**REFERENCE: HOME FRONT HEROES MINOR CPD
DCI2023-00047
2nd Sufficiency Response**

This letter is written in response to the review comments dated June 12, 2024. Please note that the request has been revised to reflect a maximum height of 45 feet with setbacks increased ½ foot per every foot over 35 feet, consistent with Lee County Land Development Code Section 34-2174, as discussed with staff.

Open Space Exhibit

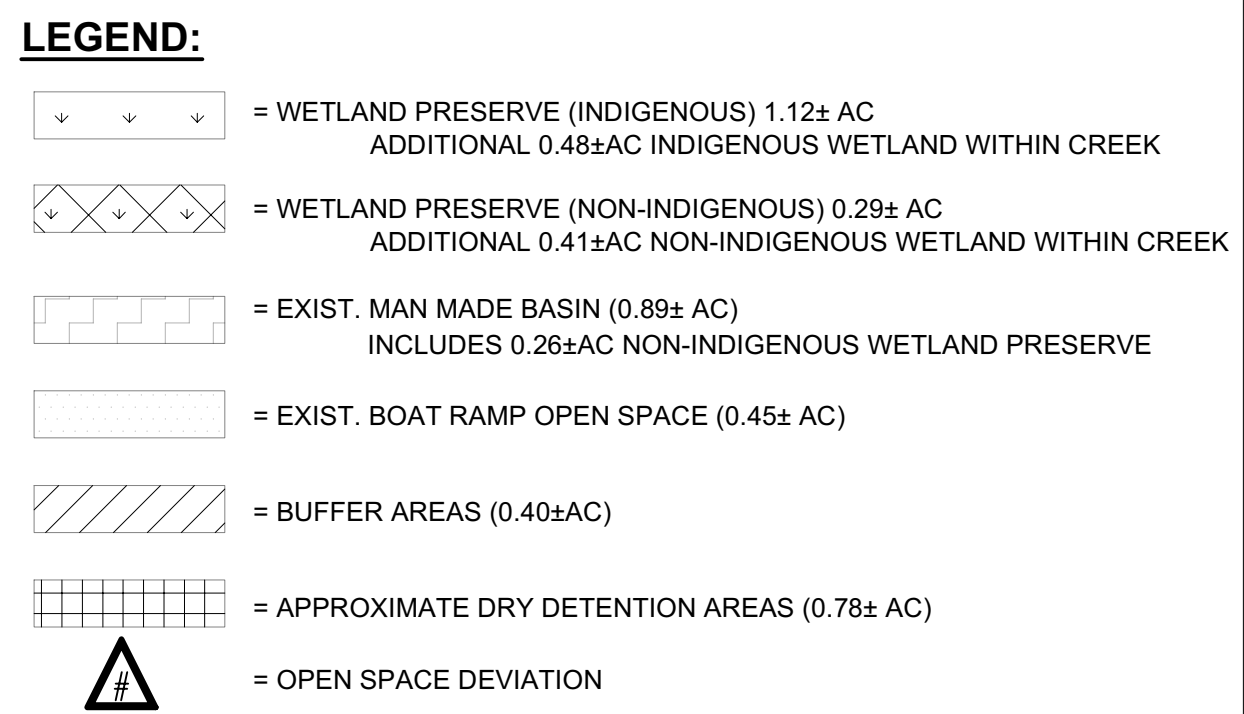
Comment 2: Staff cannot support Deviation 15. The open space and indigenous open space has been approved as part of Resolution Z-05-048 collectively. The applicant has indicated that the subject application has been revised to amend the existing zoning resolution which met the requirements of open space and indigenous open space.

Response: Pursuant to follow up discussions, please see attached revised Schedule of Deviations and Justifications and Conceptual Open Space Plan. The request has no impact to the existing approved open space areas provided for the Moody River Estates development.

Protected Species Survey Map with Bald Eagle Buffer Zones

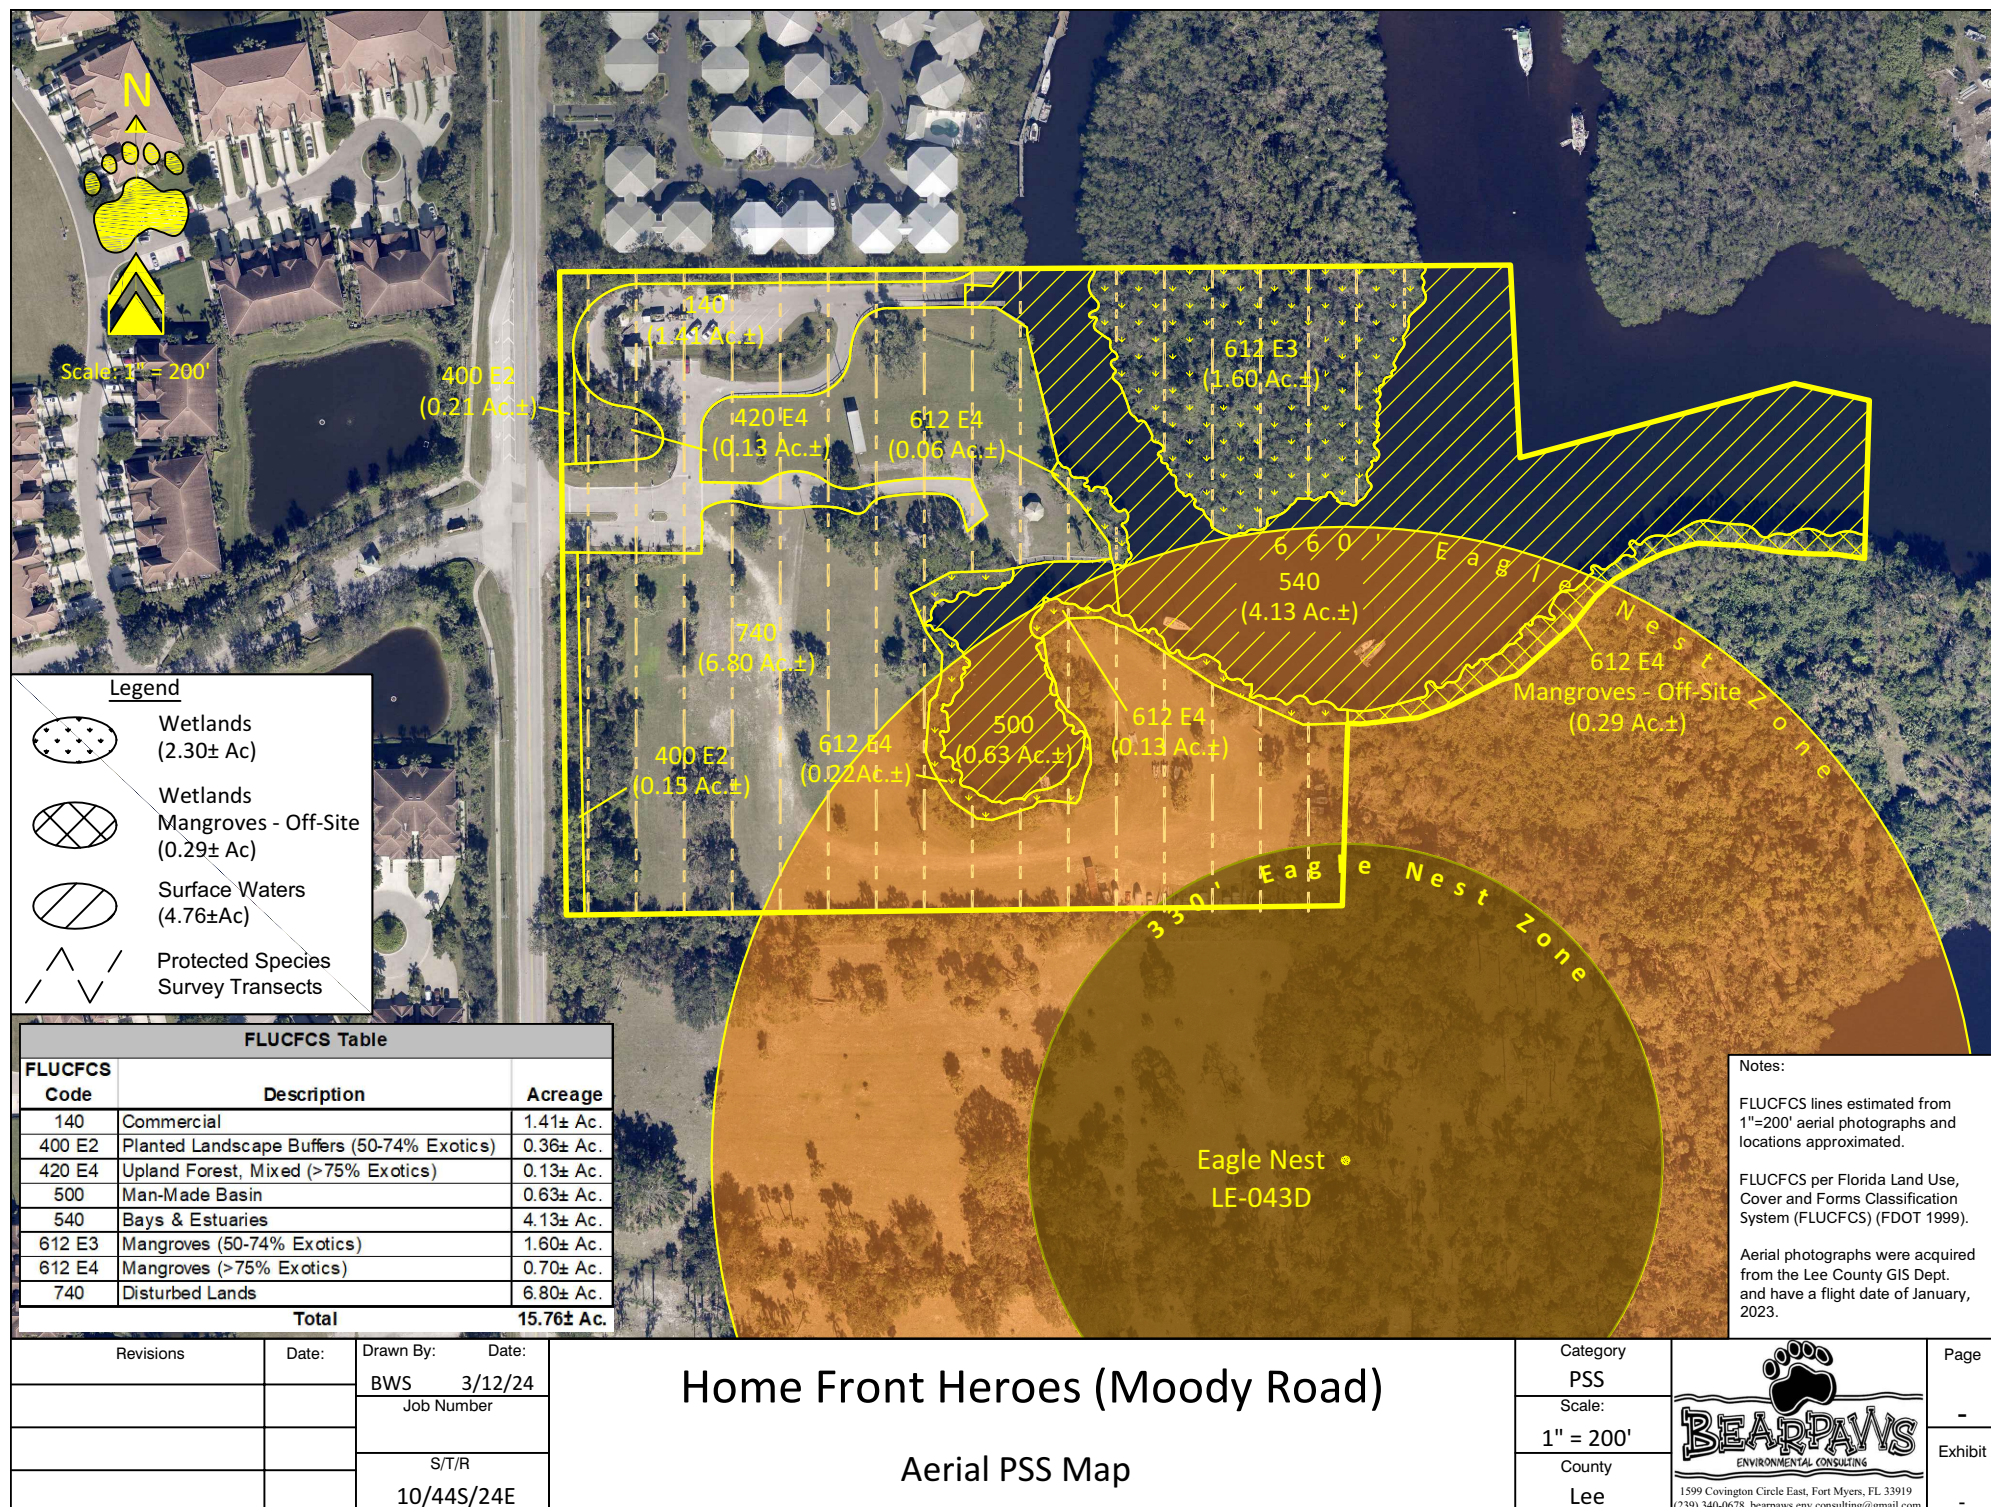
Comment 2: Please revise the MCP to depict 330' and 660' buffer lines from the correct nest location shared with the applicant's consultant team on 6/6/2024.

- 1) Please revise all exhibits based on the accurate nest location obtained by Staff and provided to the applicant.
- 2) Please revise the "330 feet Zone Activities and Restrictions" to address proposed improvements within 330 feet of the nest based on accurate nest location provided to the applicant. What conservation measures will the applicant implement to minimize

Response: Please see attached revised MCP and revised BEMP.

BOUNDARY SURVEY
A PORTION OF SECTION 10, TWP 44S, RNG 24E
LEE COUNTY, FLORIDA

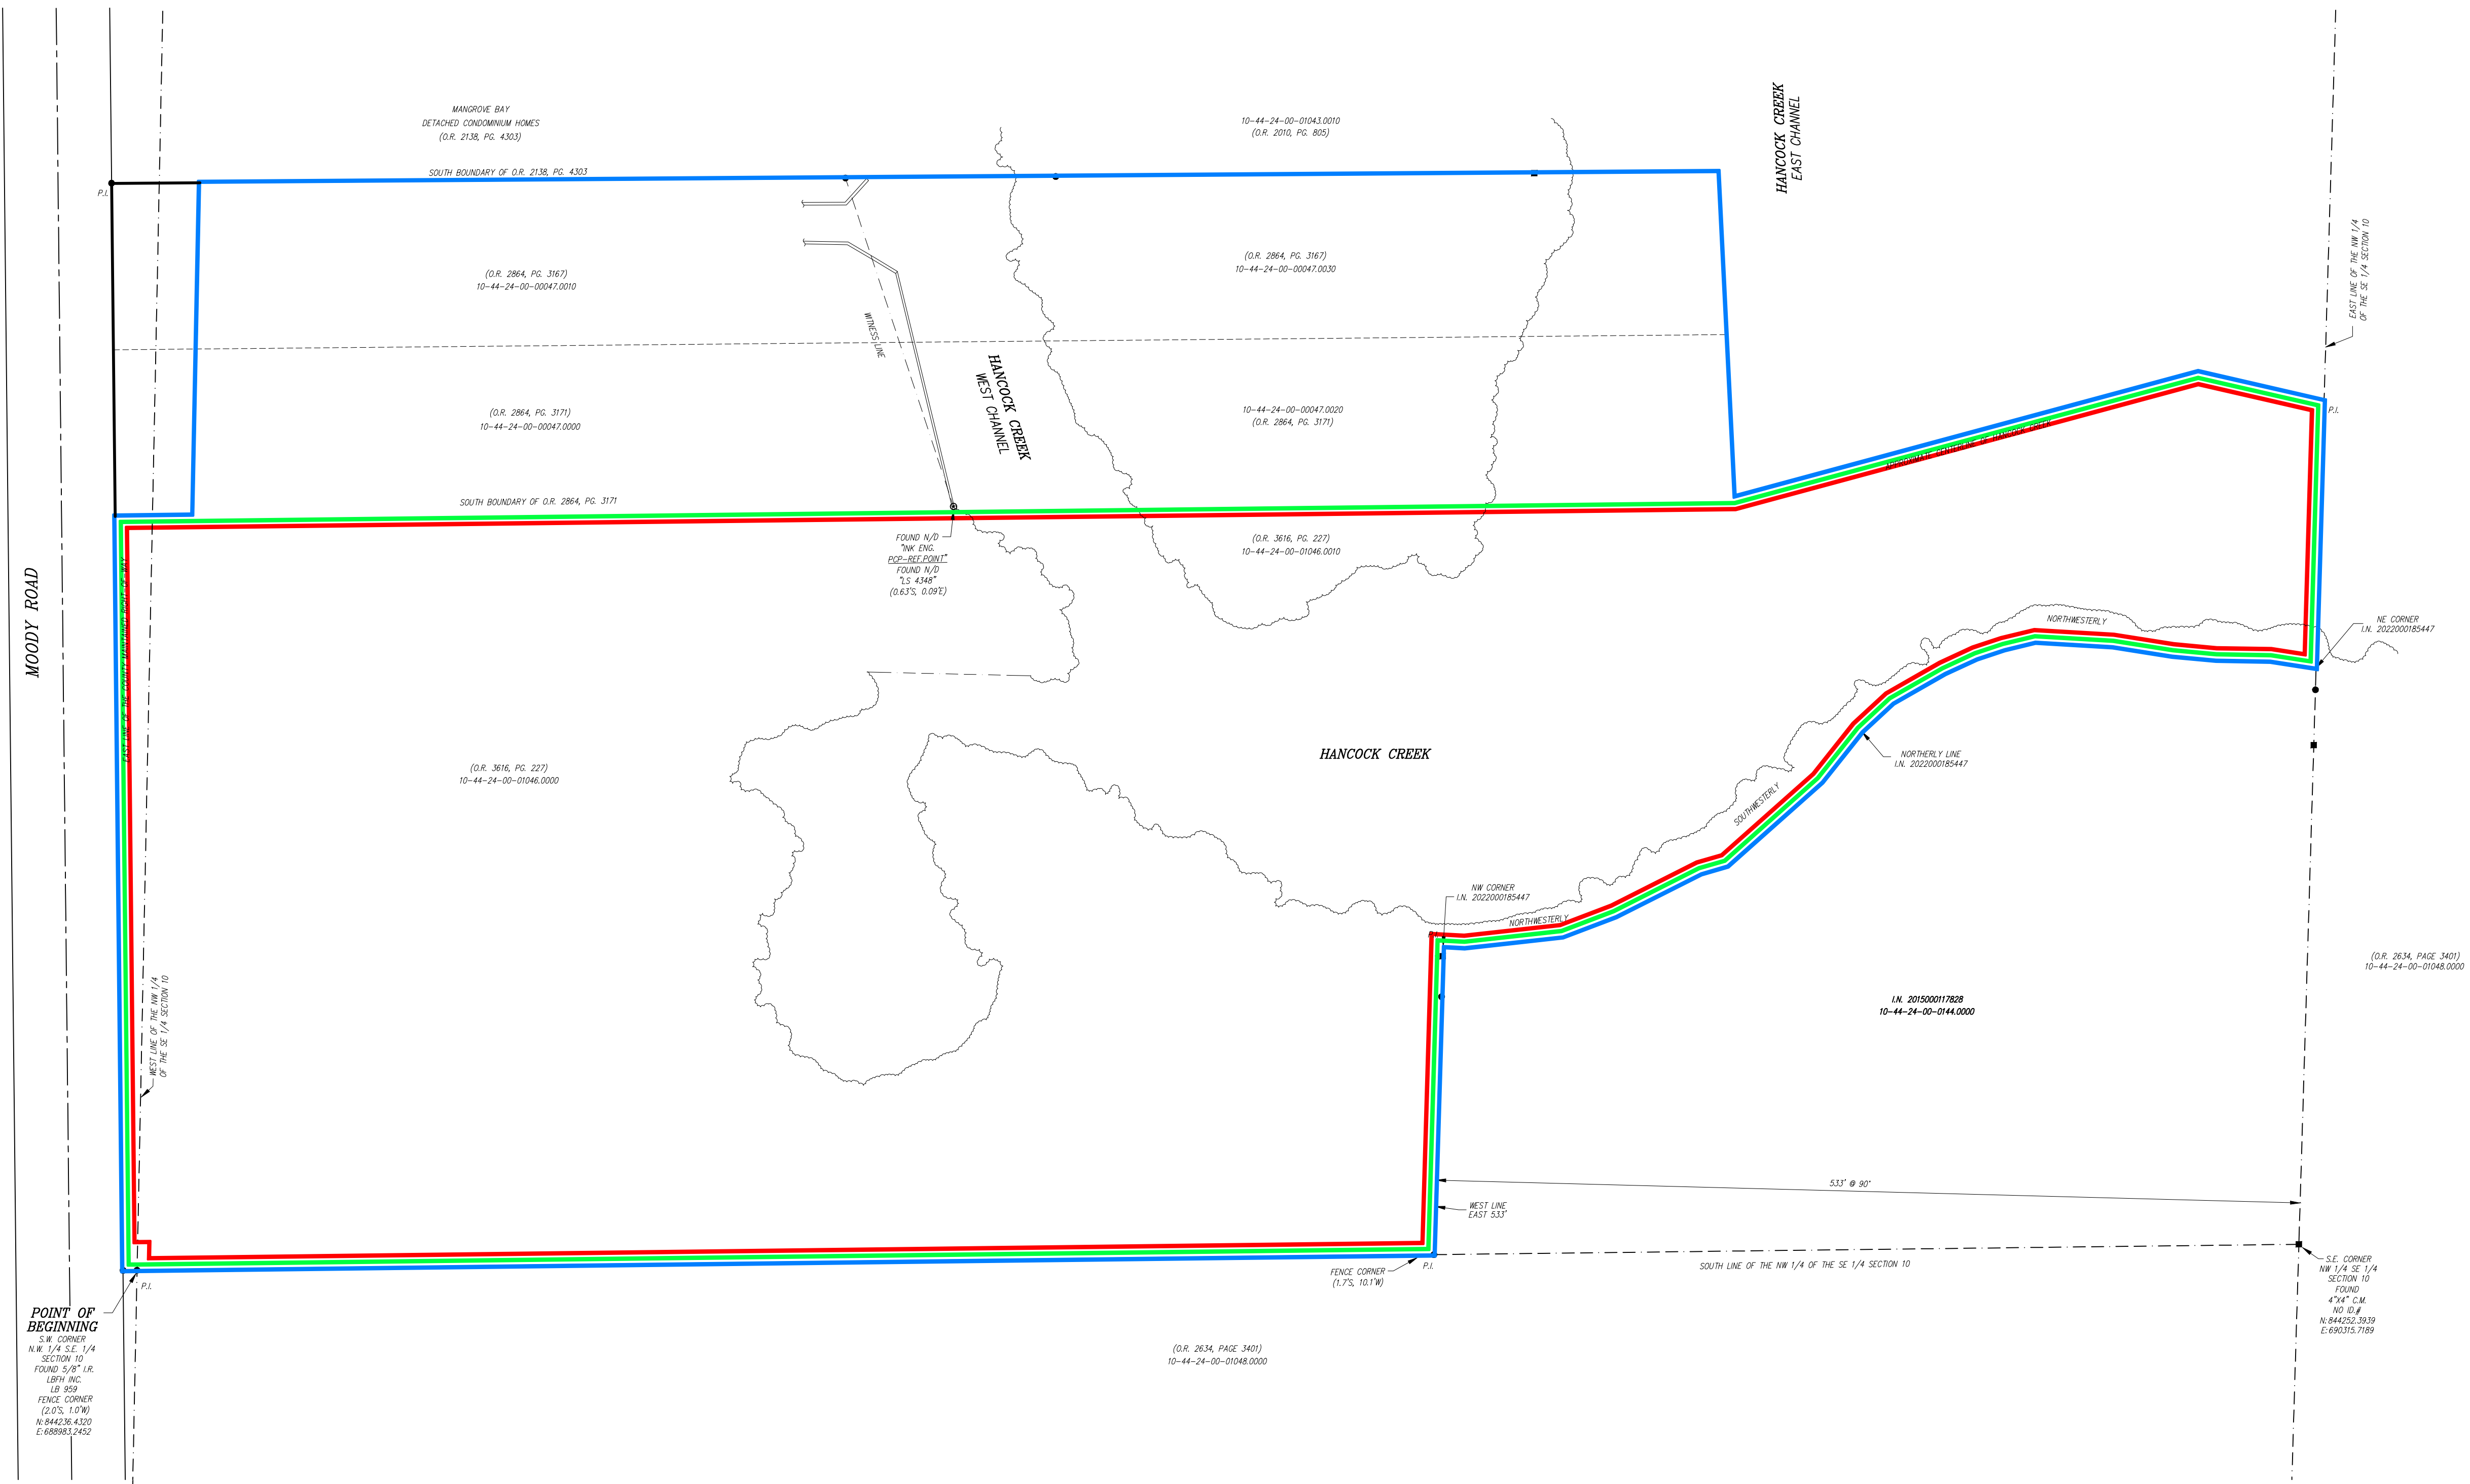
Comment 1: Sec. 34-202(a). Submittal requirements for applications requiring public hearing.
(6) Please provide a boundary survey of the subject property in accordance with the requirements of Lee County LDC §34-202(a)(6).
- The perimeter of the subject property is not consistently depicted with a heavy line. The

Response: Please see attached revised Boundary Survey.
